**STAFF RECOMMENDATION**  
**119 and 121 3<sup>rd</sup> Avenue South**  
**August 18, 2021**

**Application:** New Construction—Addition  
**District:** Broadway Historic Preservation Zoning Overlay  
**Council District:** 19  
**Base Zoning:** DTC  
**Map and Parcel Number:** 09306403000 and 09306403100  
**Applicant:** Stewart Dorn, Remick Architecture  
**Project Lead:** Melissa Baldock, melissa.baldock@nashville.gov

<p><b>Description of Project:</b> Applicant proposes two rooftop additions; one over 119 3<sup>rd</sup> Avenue South and one over 121 3<sup>rd</sup> Avenue South.</p> <p><b>Recommendation Summary:</b> With the condition that staff approve all final material choices prior to purchase and installation, staff finds that the proposed rooftop additions meets Section III. of the design guidelines for the Broadway Historic Preservation Zoning Overlay.</p>	<p><b>Attachments</b> <b>A:</b> Site Plan <b>B:</b> Elevations</p>
--	--

Figure 1 (left) is 121 3<sup>rd</sup> Avenue South. Figure 2 (right) is 119 3<sup>rd</sup> Avenue South.

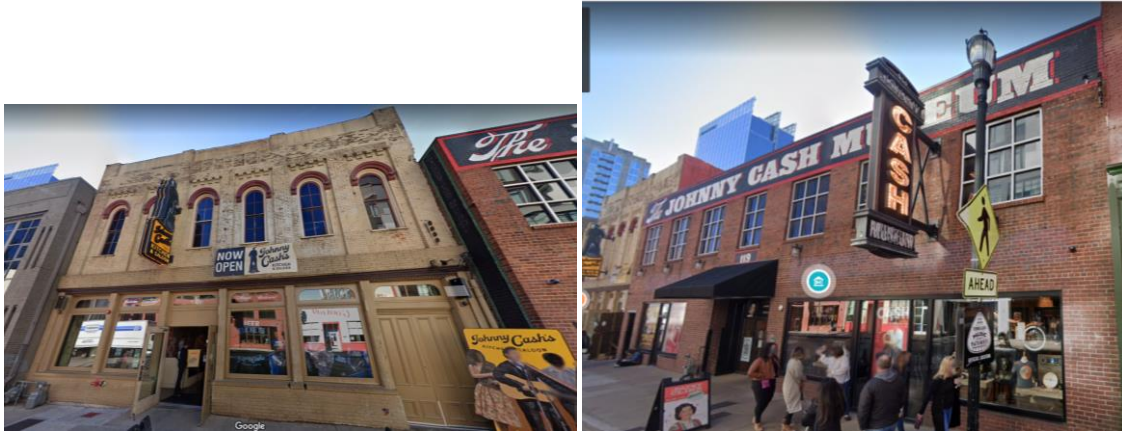
**Background:** 119 and 121 3<sup>rd</sup> Avenue South are two separate structures. 121 3<sup>rd</sup> Avenue South is a two-story commercial structure constructed c. 1890 (Figure 1). 119 3<sup>rd</sup> Avenue South is a two-story commercial structure constructed c.1920 (Figure 2). Both structures contribute to the Broadway Historic Preservation Zoning Overlay.

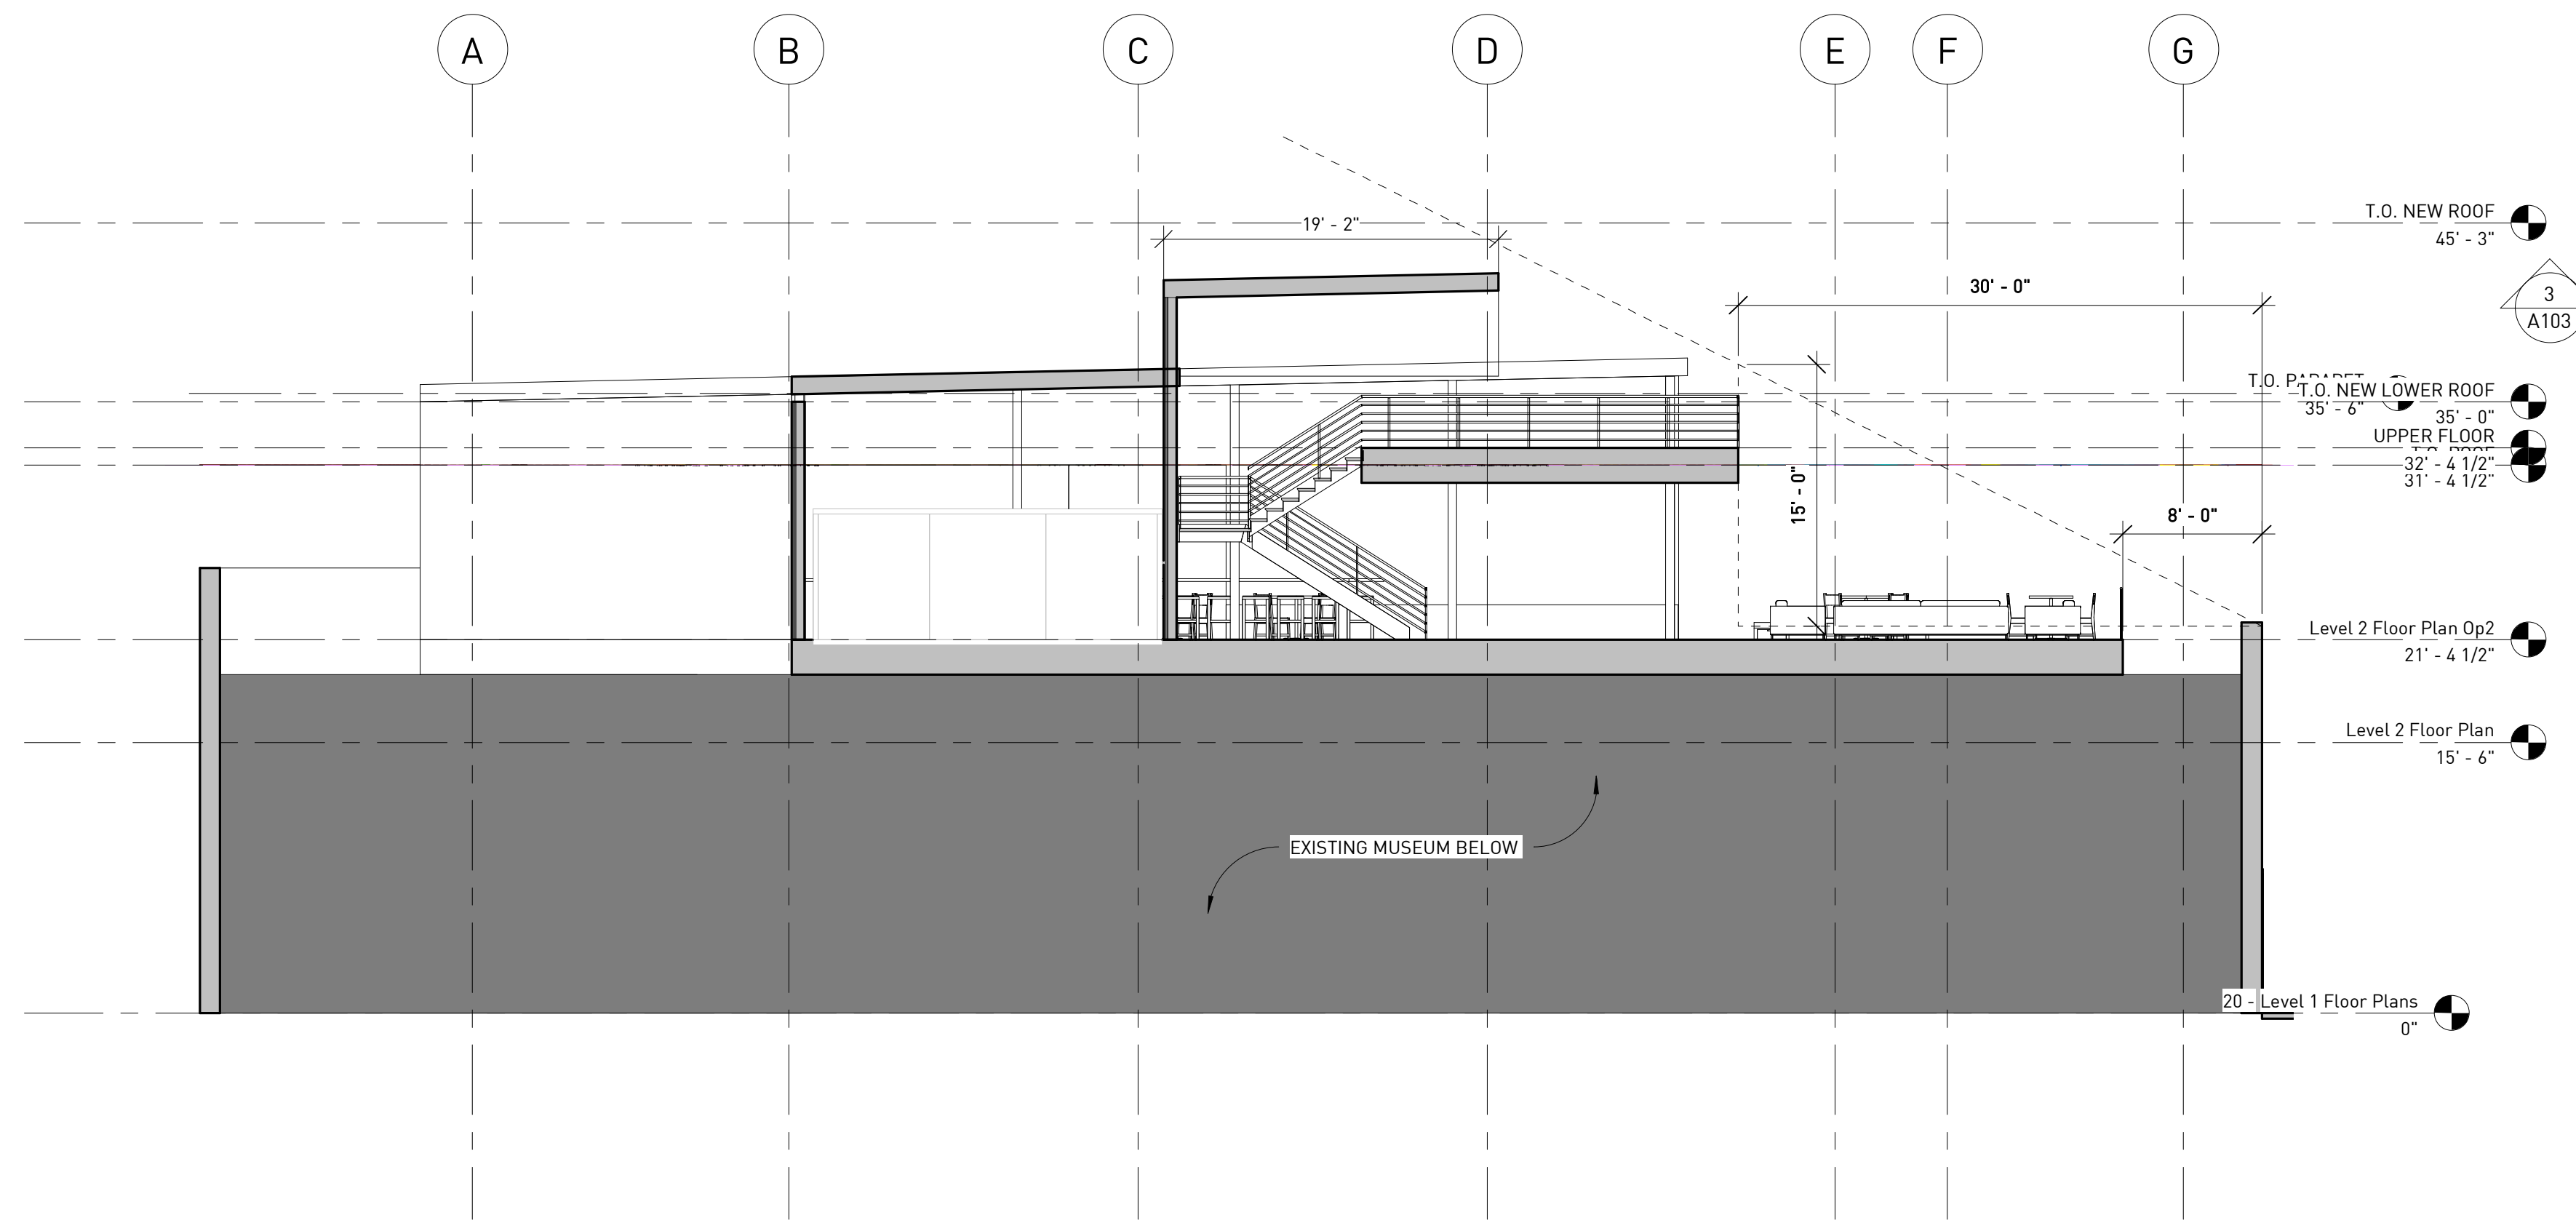
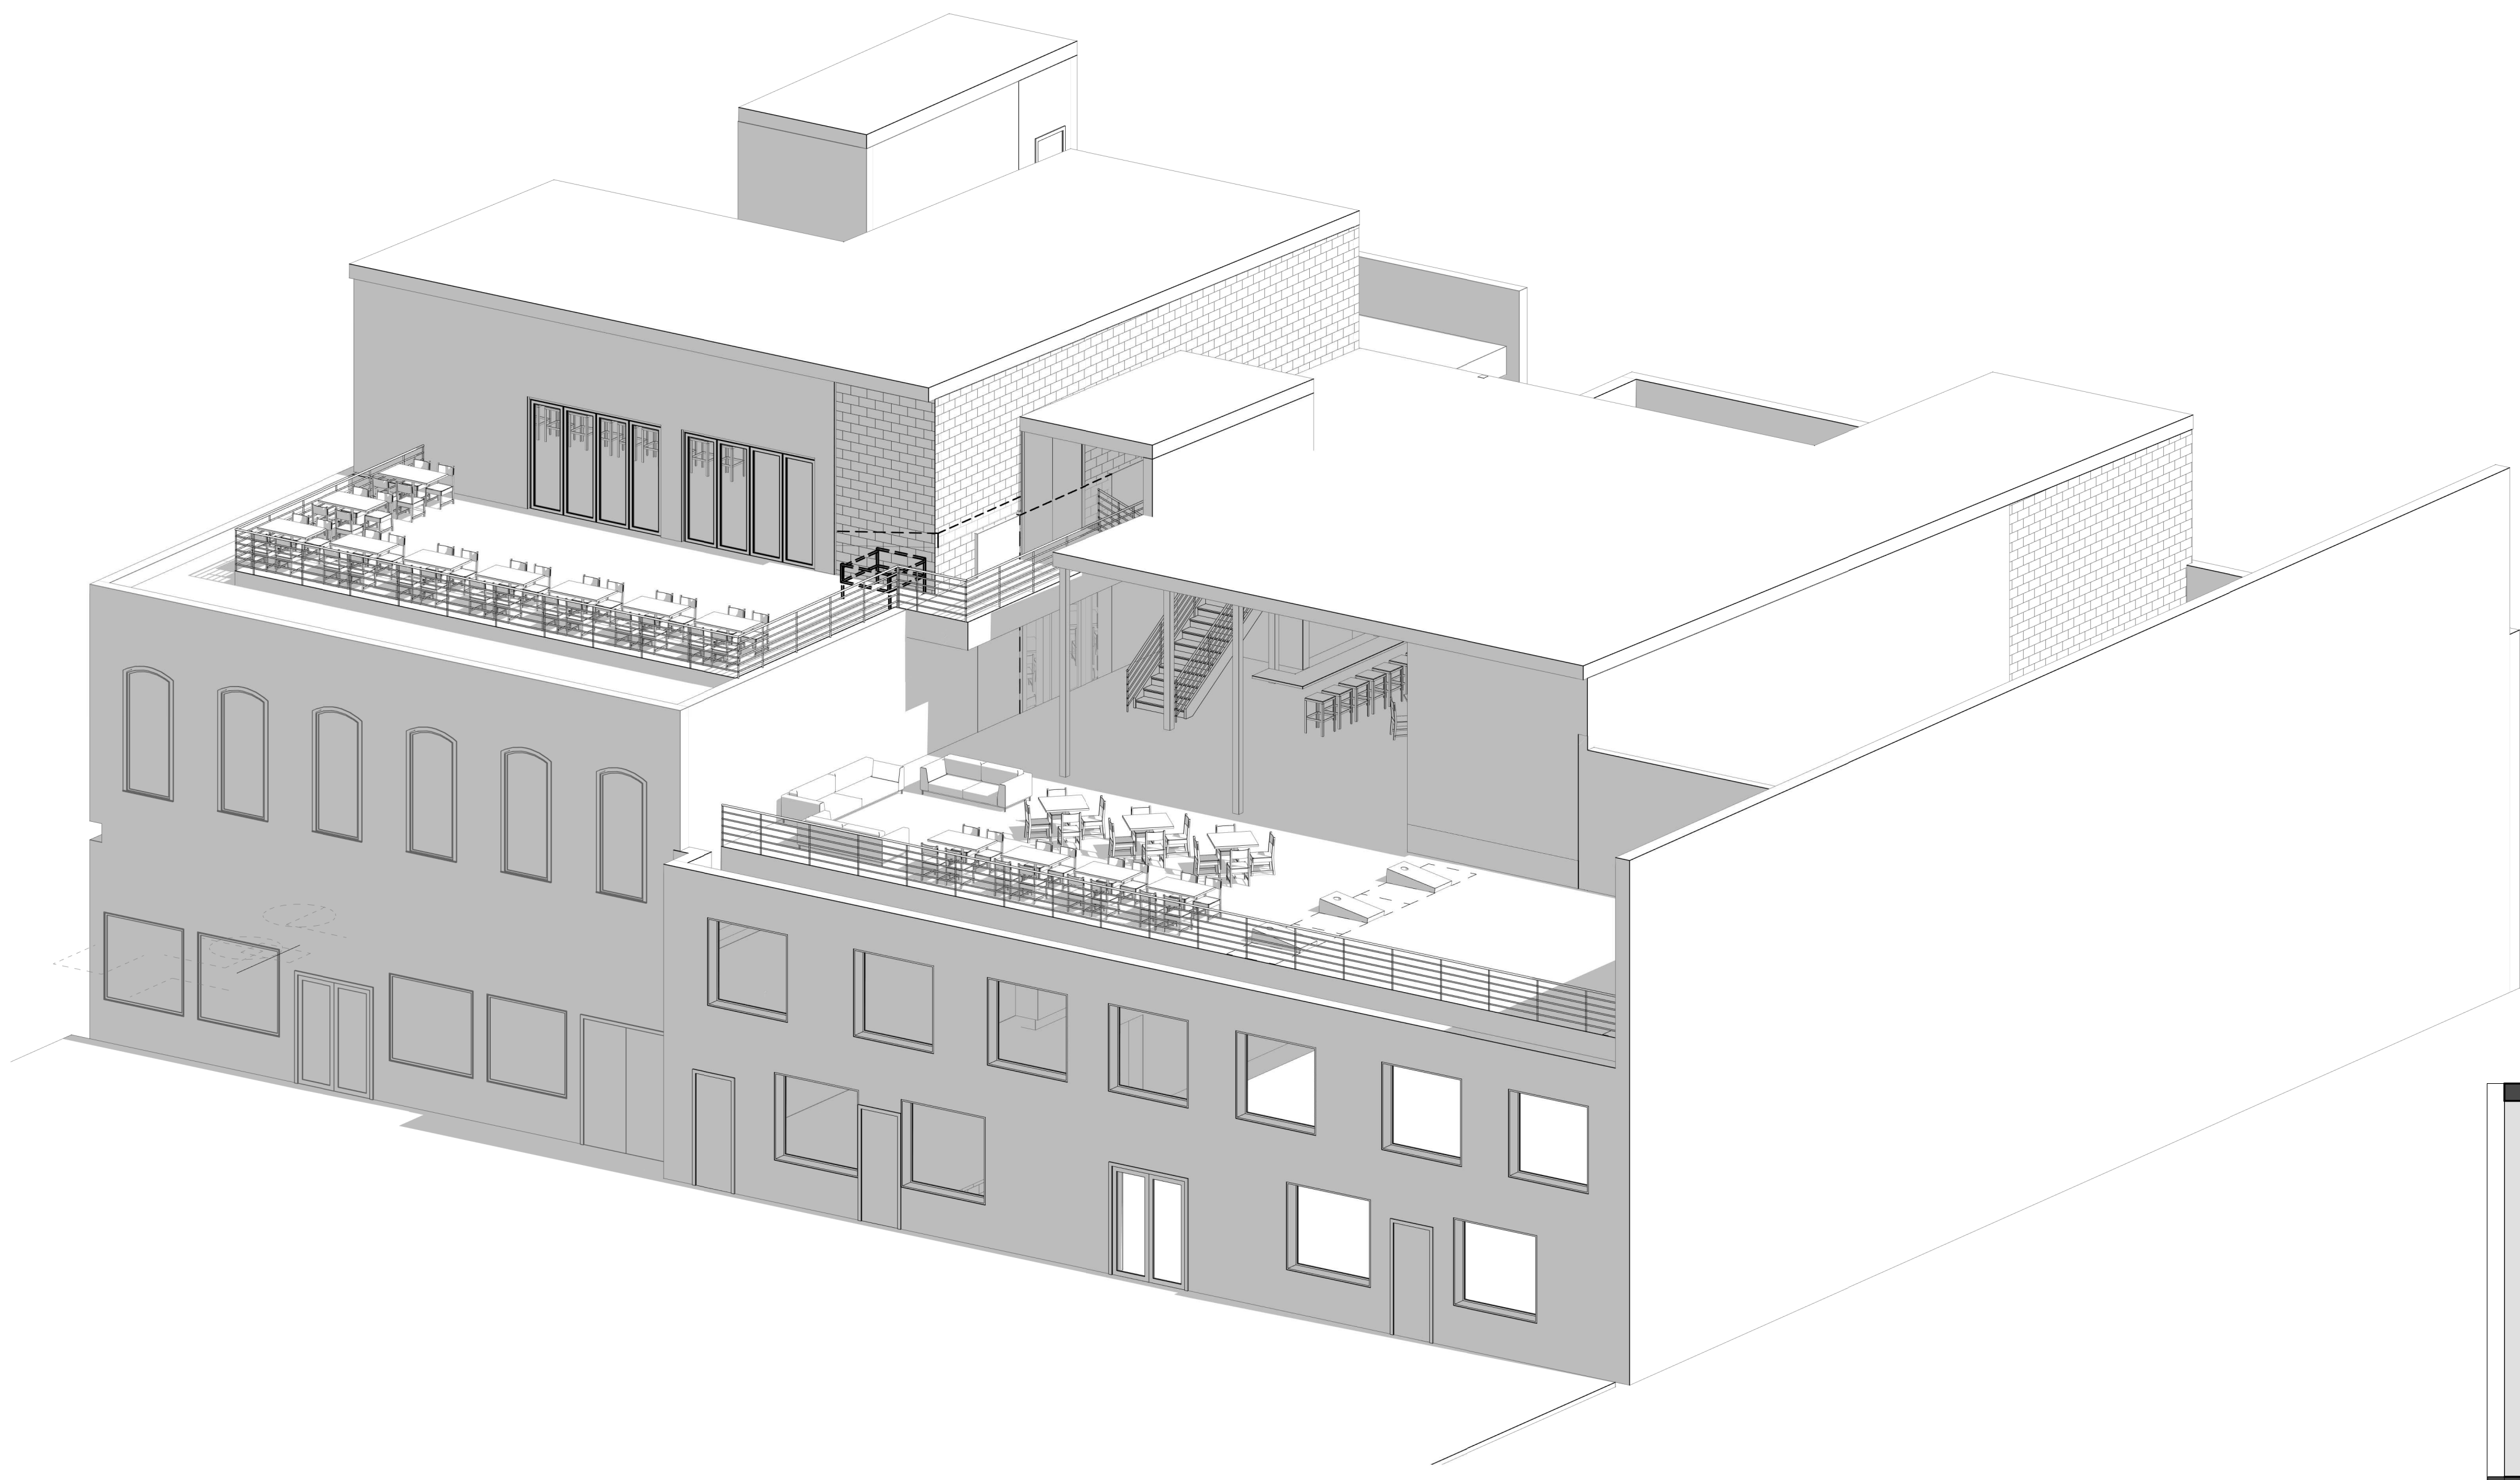
Rooftop Additions Height, Scale and Setback. Rooftop additions are proposed for both 119 and 121 3<sup>rd</sup> Avenue South. Although both historic structures are two-stories in scale, they are different heights. 121 3<sup>rd</sup> Avenue South is approximately ten feet (10') taller than 119 3<sup>rd</sup> Avenue South. Most of the rooftop additions on both structures meet the requirement that the rooftop addition should not be taller than one story and fifteen feet (15') above any parapet. The rooftop additions also meet the requirement that they be stepped back thirty feet (30') from the front façade.

Because the two roofs are at separate heights, share the same owner, and the owner wishes to connect the two rooftop spaces, there is a small portion of the rooftop addition over 119 3<sup>rd</sup> Avenue South that exceeds the fifteen foot (15') tall requirement and is twenty-five feet (25') tall. Staff finds this taller portion to be appropriate in this instance for two reasons. One, the taller portion only covers a small portion of the roof over 119 3<sup>rd</sup> Avenue south – it is just approximately ten feet (10') wide, whereas the overall width of the roof is close to eighty feet (80'). And two, the application has stepped this taller portion of the addition back approximately forty-five feet (45'), helping to reduce its visibility and impact on the scale of the historic structure. Overall, staff finds that this taller portion is modest in scale and will not be highly visible.
